### REMARKS

Applicants present the attached Replacement Sheets of formal drawings which include amended Figures 8A, 8B, 10-14 and 16. These sheets replace the original sheets.

Docket No. T0450.70036US00  
Date: August 11, 2004  
**xNDD**

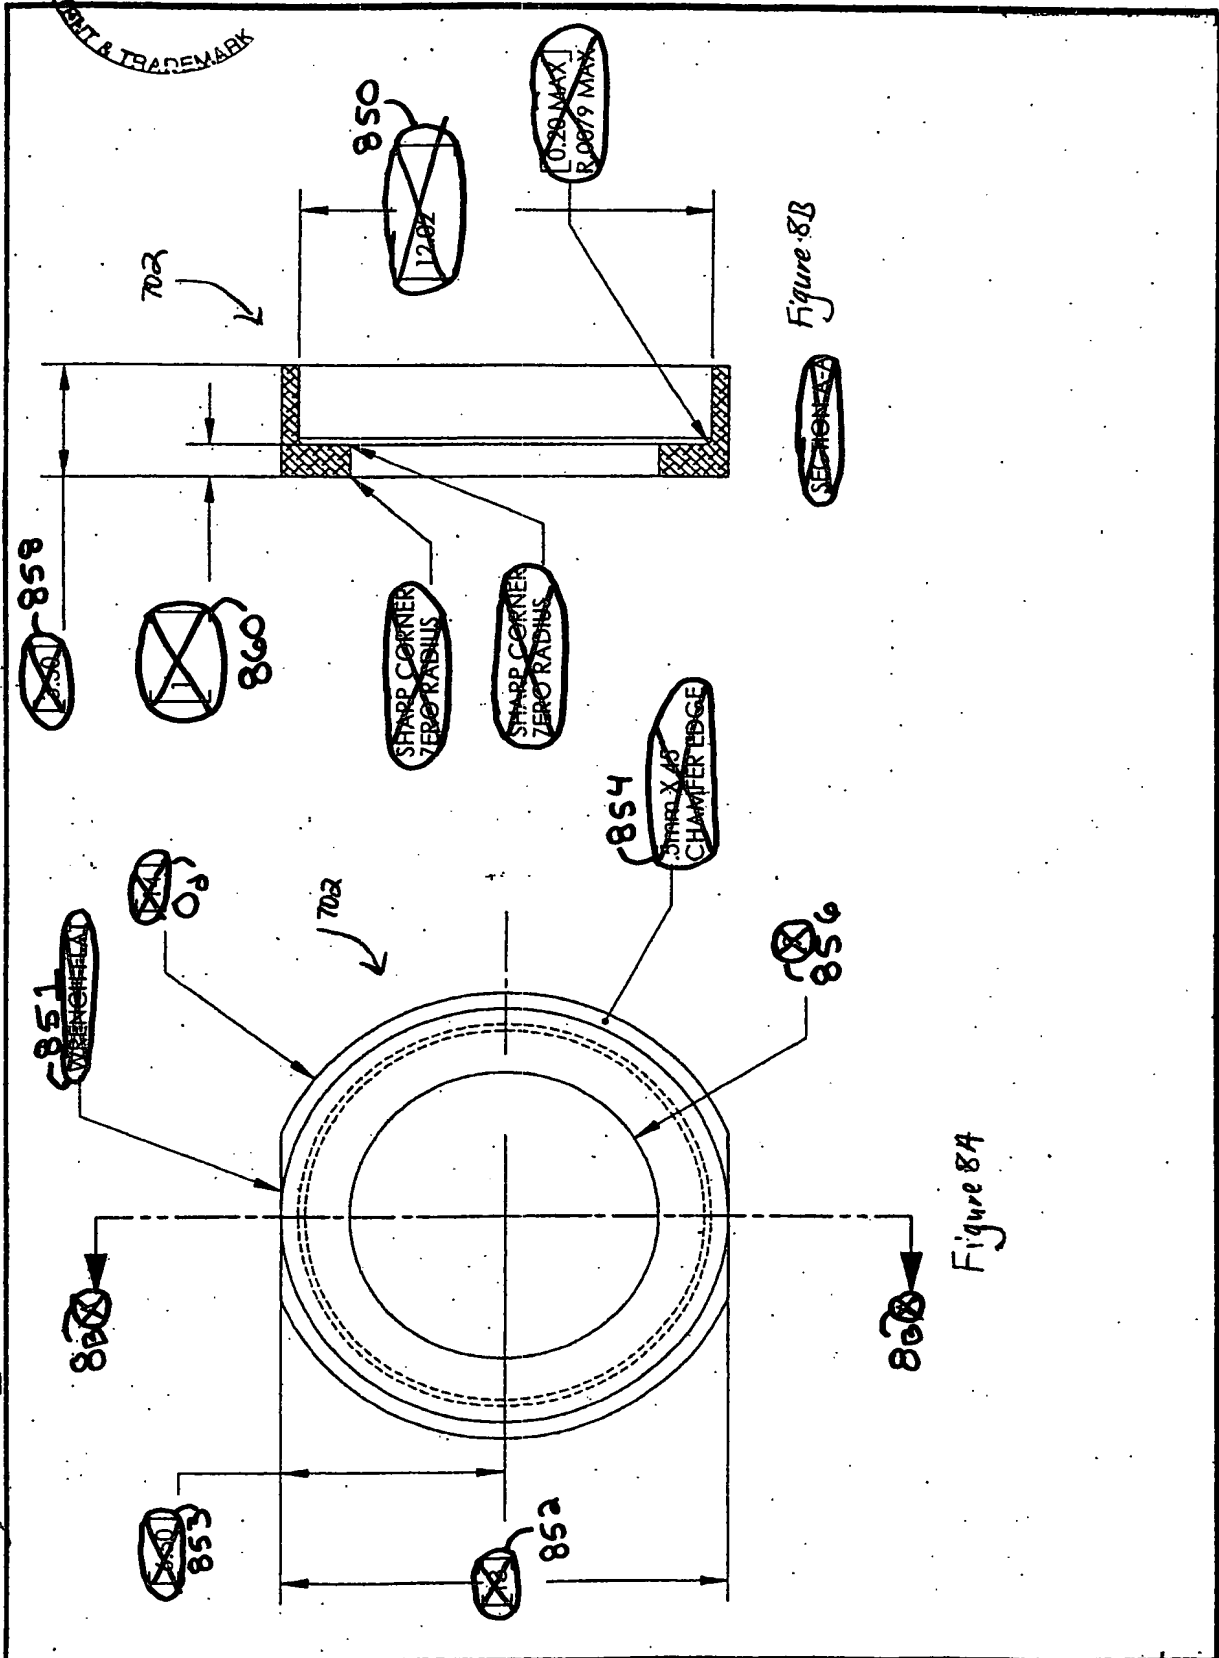
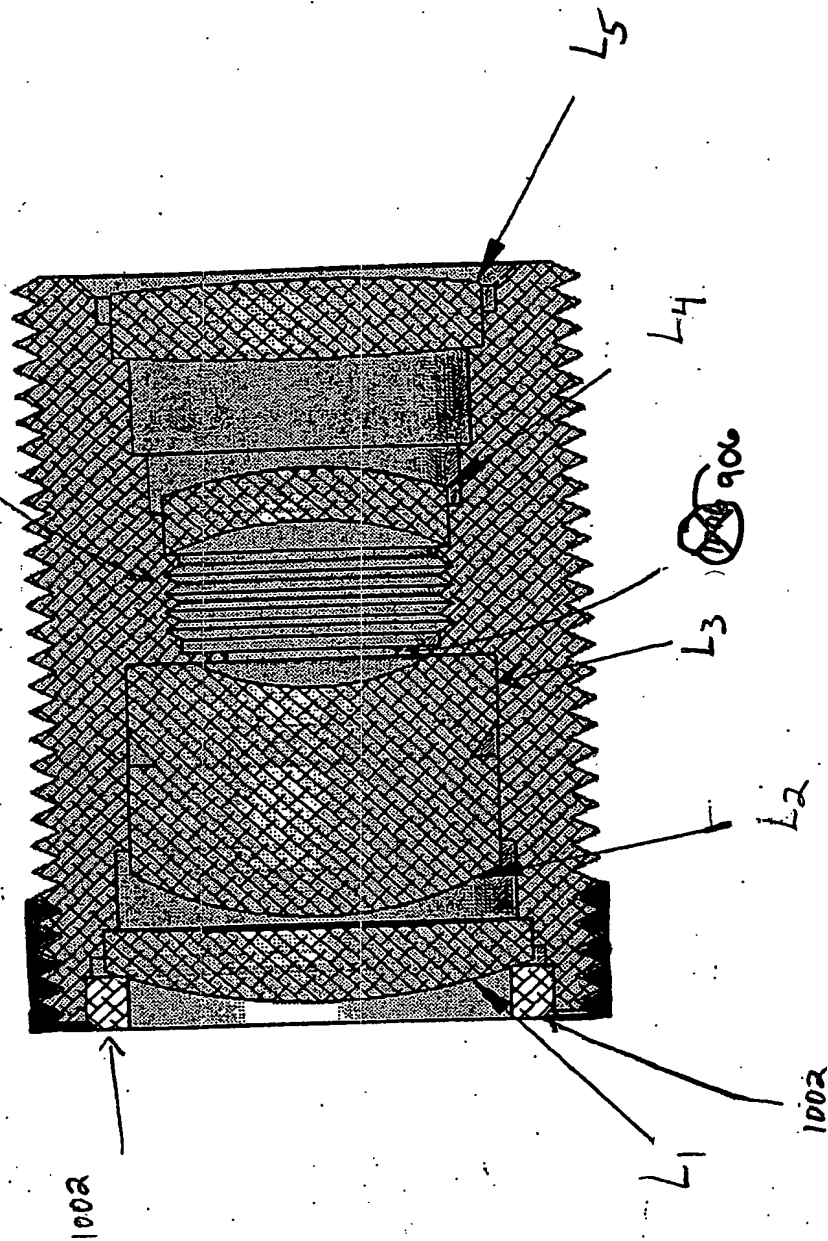
Figures 8A, 8B, 11A and 11B were amended to remove exemplary dimensions and to add reference characters to designate those dimensions. In particular, in Figure 8A, dimension "6.50" is replaced with reference character "853," dimension "13" is replaced with reference character "852," dimension "9" is replaced with reference character "856," dimension "14" is replaced with reference character "0<sub>d</sub>," and dimension ".5mm X 45° chamfer edge" is replaced with reference character "854." In Figure 8B, dimension "12.02" is replaced with reference character "850," dimension "3.50" is replaced with reference character "858," and dimension "1" is replaced with reference character "860." In Figure 11A, dimension "6.75" is replaced with reference character "1162" and dimension "8.20" is replaced with reference character "1160." In Figure 11B, dimension "1" is replaced with reference character "1164" and dimension ".008[.20] X 45° chamfer" is replaced with reference character "1166."

In addition, exemplary edge descriptions, such as "sharp corner zero radius," and "[0.20 MAX] R.0079 MAX," were removed from Figures 8B and 11B.

In Figures 8A and 11A, lines A-A have been respectively renamed as line 8B-8B and line 11B-11B.

Figure 8A was also amended to remove the identifier "wrench flat" and to add reference character "851" to designate the area that "wrench flat" formerly identified.

Figure 10 ~~914~~

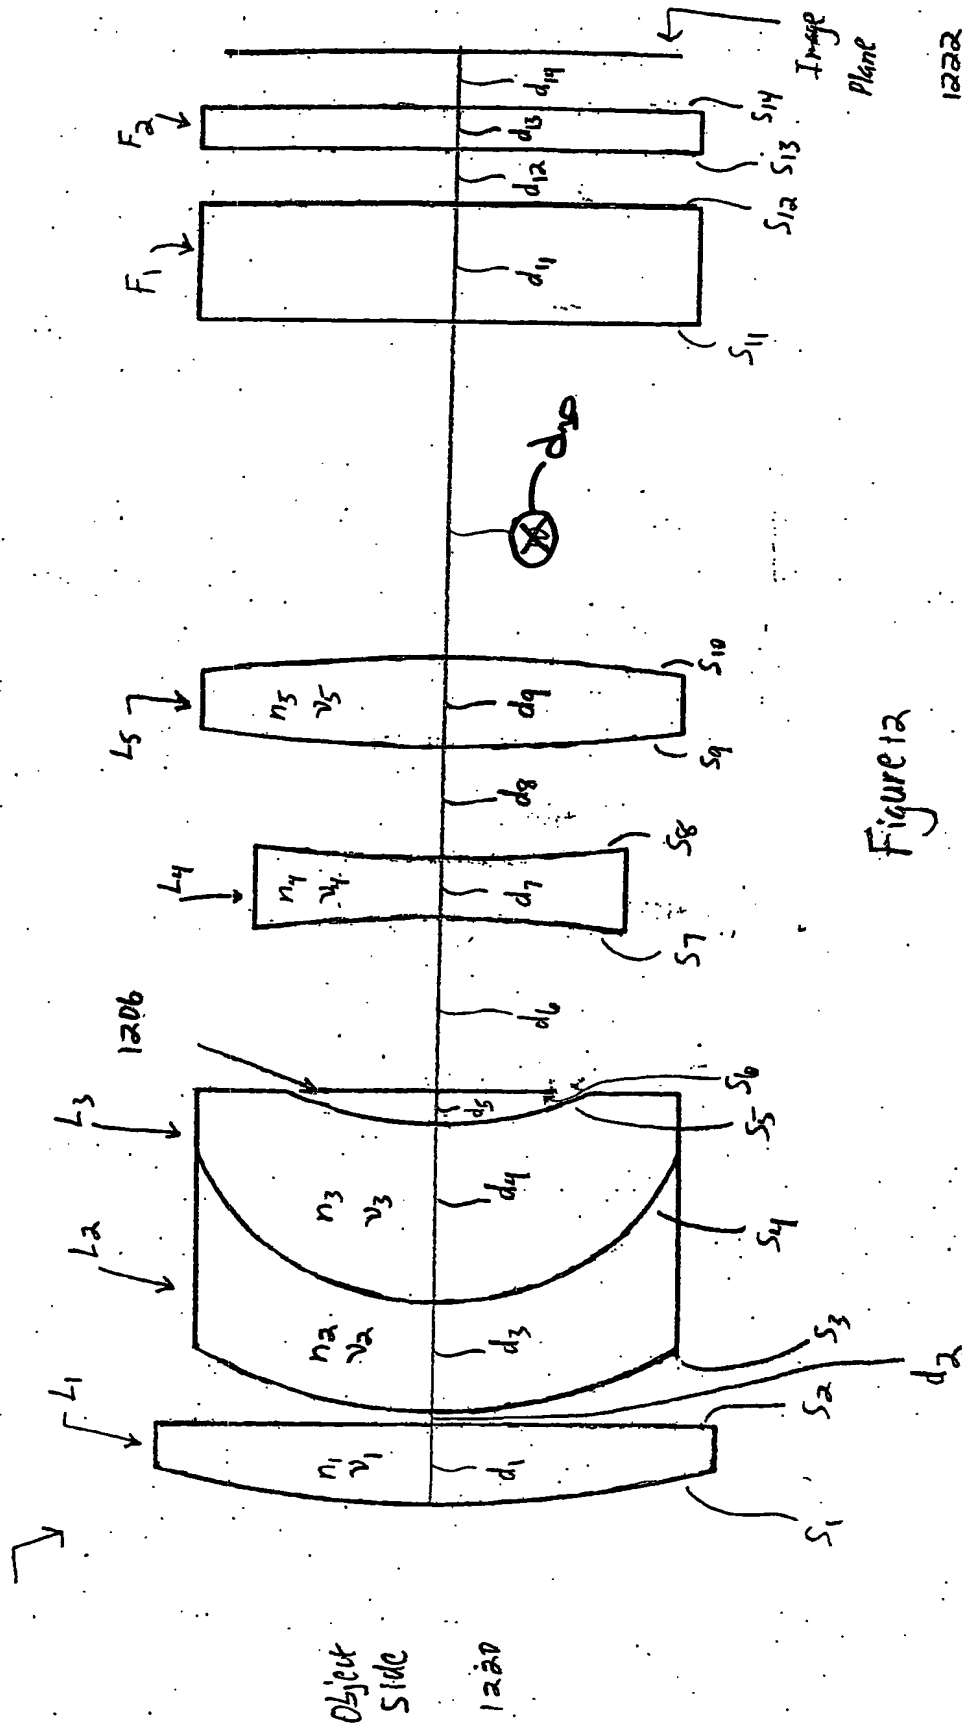
Figure 10 has been amended to replace reference characters "1006" and "1014" with "906" and "914," respectively. Figure 10 has also been amended to show a portion of the housing that does not contain threads.

Figure 13

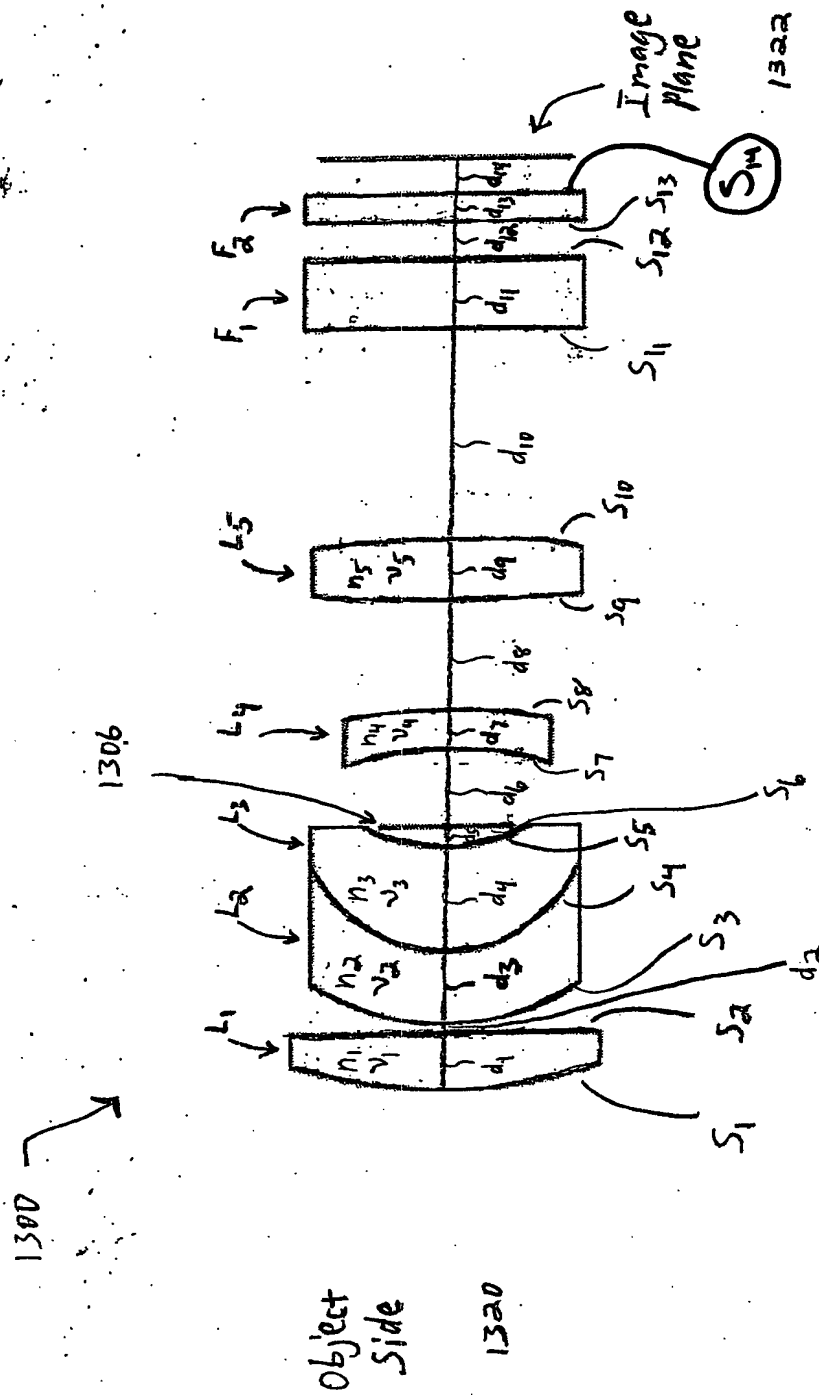
Reference character "S<sub>14</sub>" was inadvertently omitted from Figure 13 and has been added.

Figure 14

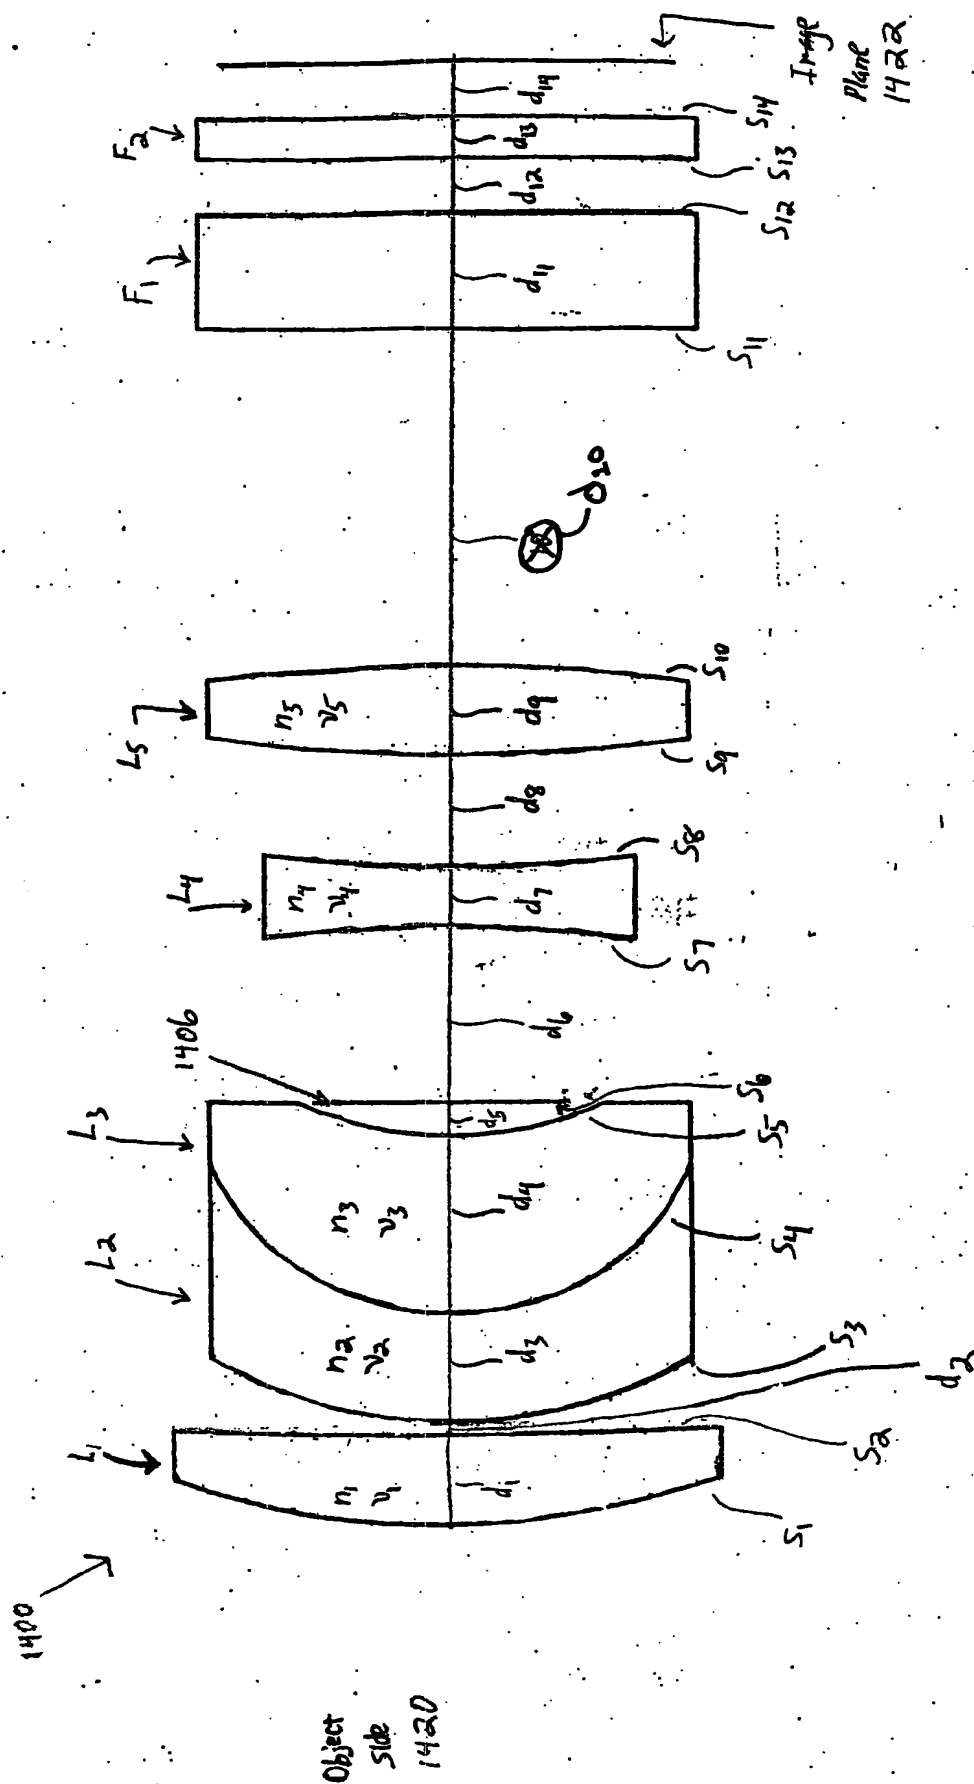
Figures 12 and 14 were amended to include reference character "d<sub>10</sub>" which was formerly incorrectly labeled as "10."

Figure 16

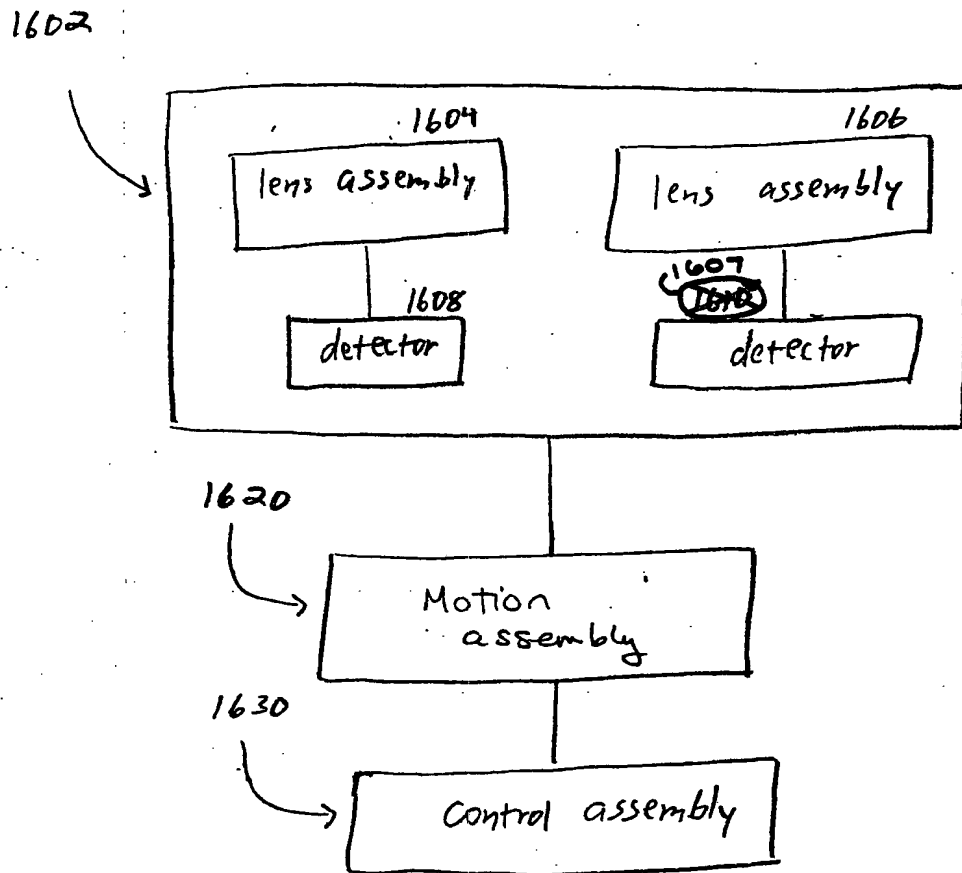
In Figure 16, reference character “1610” was changed to “1607” since reference character “1610” was already used to designate the housing in Figure 17.
